Historic Architectural Review Commission Staff Report for Item 7

Application Number: H2023-0026

Address: 1215 Grinnell Street

Description of Work:

Photograph of the house front elevation with proposed demolition marked in red.

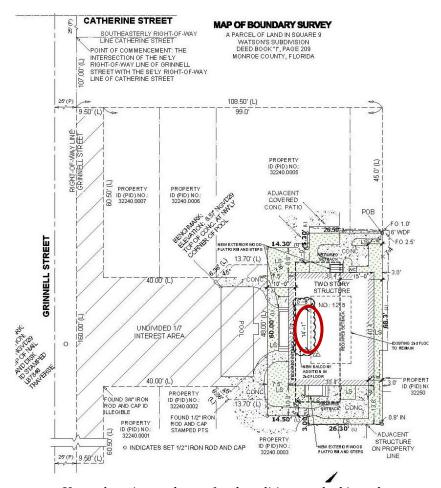
The Certificate of Appropriateness proposes the partial demolition of front roofs and second floor front wall. Staff opines the proposed demolition will not have any adverse effect on surrounding buildings.

It is staff's opinion that the architectural elements under review are not important character defining features to the site or surrounding urban context.

The proposed structural elements to be demolished are not historic.

The non-historic architectural elements are not significant to the house or the complex.

It is staff's opinion the portions of building under review will not qualify to be contributing to the district in a near future.

Staff recommends to the Commission the consideration of this request for demolition as proposed for non-historic structural components. The house and the architectural elements are not historic and are not part of a significant residential complex within the historic district. If the Commission finds the design to be appropriate this will be the only required reading for demolition.
